Re: Rankin Training Facility
720 Rankin Rd., NE
Traffic Circulation Layout *2061*
Engineer's/Architect's Stamp **3-9-16 (G15-D0641)**

Based upon the information provided in your submittal received 6-14-16, the above referenced plan cannot be approved for Building Permit until the following comments are addressed:

DRAINAGE AND TRANSPORTATION INFORMATION SHEET (REV 09/2015)

**RANKIN TRAINING FACILITY
SITE RENOVATIONS**
 720 RANKIN RD. NE ALBUQUERQUE, NEW MEXICO 87107

B2 TRAFFIC CIRCULATION LAYOUT PLAN
1"= 20'-0"

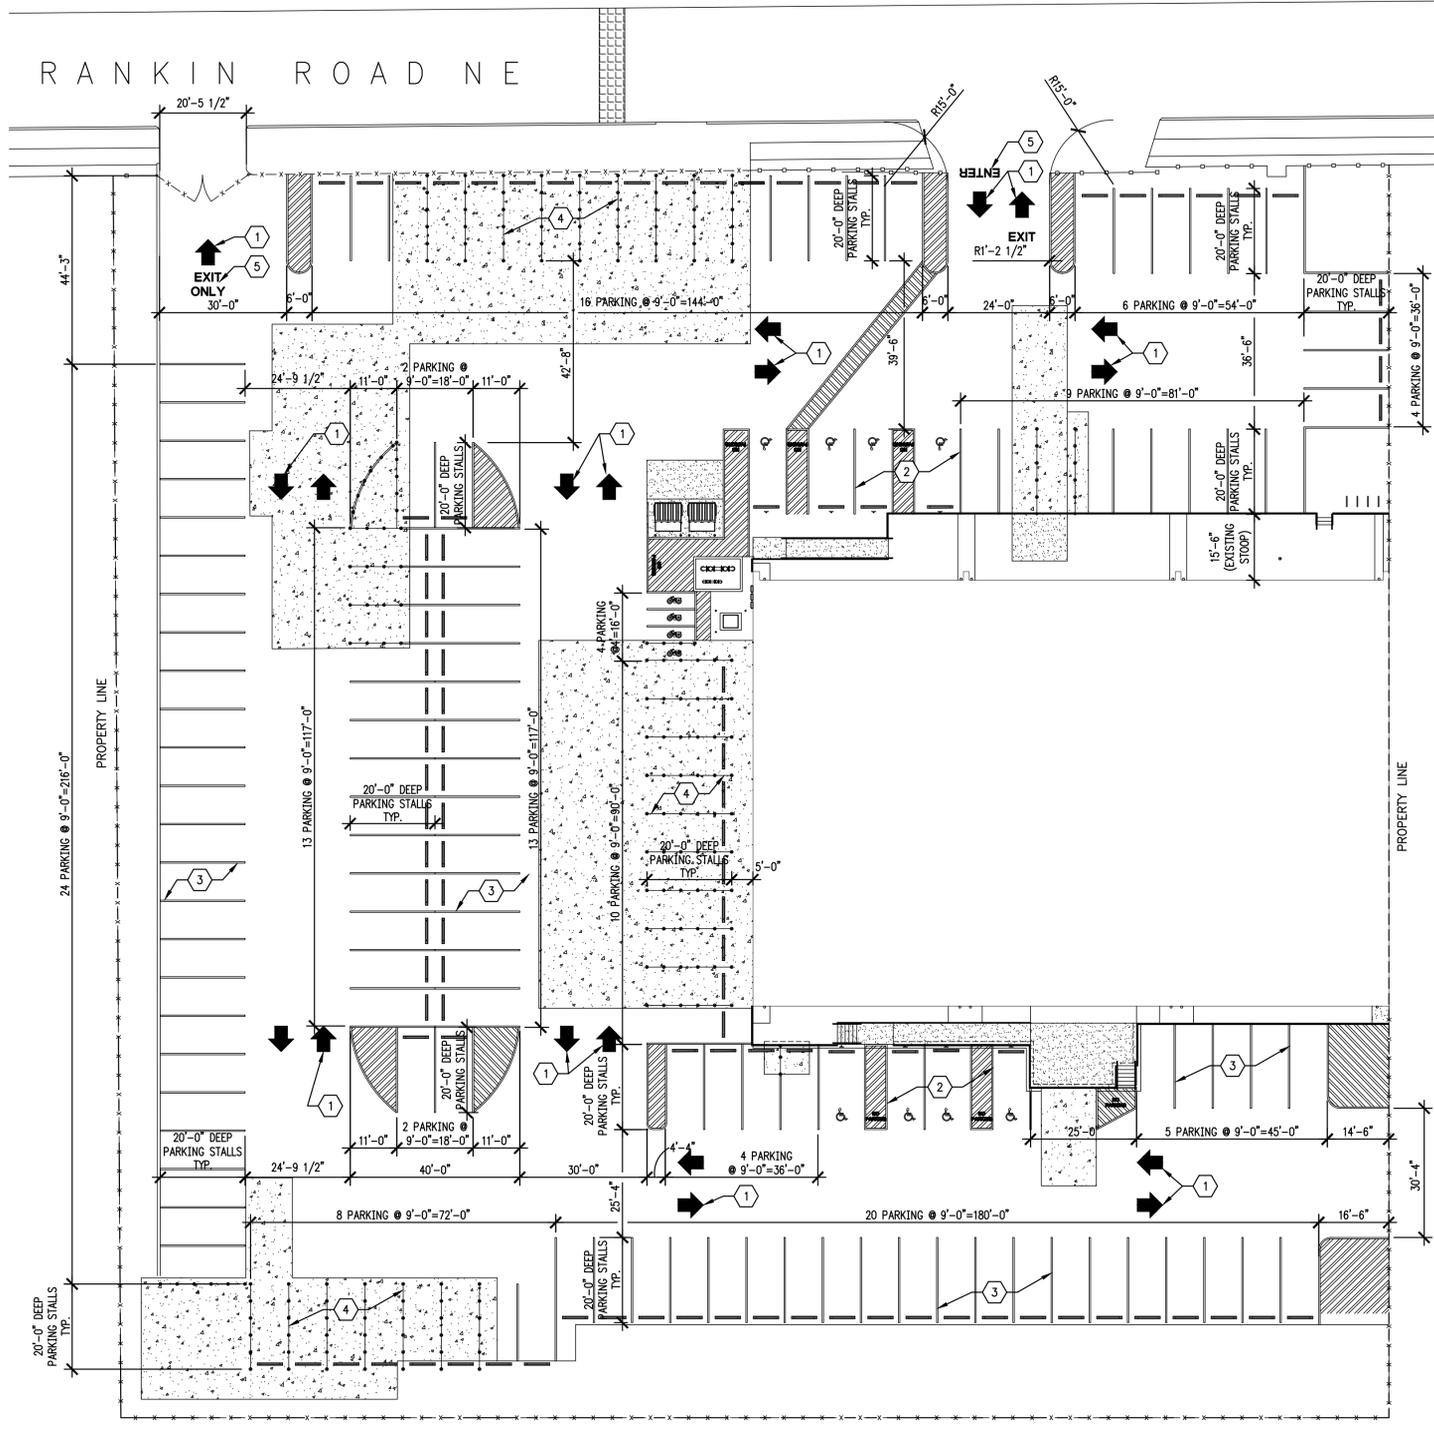
1. Please show a vicinity map showing the location of the development in relation to streets and well known landmarks.
2. List the number of parking spaces required by the zoning code as well as the proposed number of parking spaces.

3. Clarify the extents of the current phase.
4. Please identify and dimension all existing buildings, doors, structures, sidewalks, ADA ramps, curbs, drive pads, wall and anything that influences the parking and circulation on the site.

5. Identify all existing access easements and rights of way width dimensions.
6. Identify the right of way width, medians, curb cuts, and street widths on Rankin Rd.

7. Please list the width and length for all existing and proposed parking spaces. Dimension all HC parking spaces and HC Access Isles.
8. The handicap accessible spaces must include an 8 ft. wide van access aisle; all other aisles should be 5 ft. in width.

9. The ADA accessible parking sign must have the required language per 66-7-352.4C NMSA 1978 "**Violators Are Subject to a Fine and/or Towing.**" Please call out detail and location of HC signs. Please show a detail of HC signs.

10. Show all drive aisle widths and radii.
11. Per DPM, a 6 ft. wide ADA accessible pedestrian pathway is required from the public sidewalk to the building entrances. Please clearly show this pathway and provide details and dimensions at the drive pad crossing.

12. Per DPM, a 6 ft. wide ADA accessible pedestrian pathway is required from the HC parking stall access aisles to the building entrances. Please clearly show this pathway and provide details from both HC parking locations.

13. Provide a min 6" or max 8" high concrete barrier curb or other acceptable barrier between landscaping and parking areas and/or drive aisles. Please call out detail and location of barrier curb.

14. Design delivery vehicle route needs to be shown.
15. Service vehicle and/or refuse vehicle maneuvering must be contained on-site; provide a copy of refuse approval. Please provide detail of refuse container.

16. One-way vehicular paths require pavement directional signage and a posted "Do Not Enter" sign at the point of egress. Please show detail and location of posted signs.

17. It is not apparent what type of pavement surface is being proposed. A hard driving surface will be required as part of this proposed project for parking area and drive aisles.

18. Please provide a sight distance exhibit (see the *Development Process Manual, Chapter 23, Section 3*). Please provide this detail for both entrances/exits on Rankin Rd.

19. Please add the following note to the clear sight triangle: "Landscaping and signage will not interfere with clear sight requirements. Therefore, signs, walls, trees, and shrubbery between 3 and 8 feet tall (as measured from the gutter pan) will not be acceptable in this area."

20. Please specify the City Standard Drawing Number when applicable.
21. Please add a note on the plan stating "All improvements located in the Right of Way must be included on the work order."

22. Unused curb cuts must be replaced with sidewalk and curb & gutter. A build note must be provided referring to the appropriate City Standard drawing.

23. All broken or cracked sidewalk must be replaced with sidewalk and curb & gutter. A build note must be provided referring to the appropriate City Standard drawing.
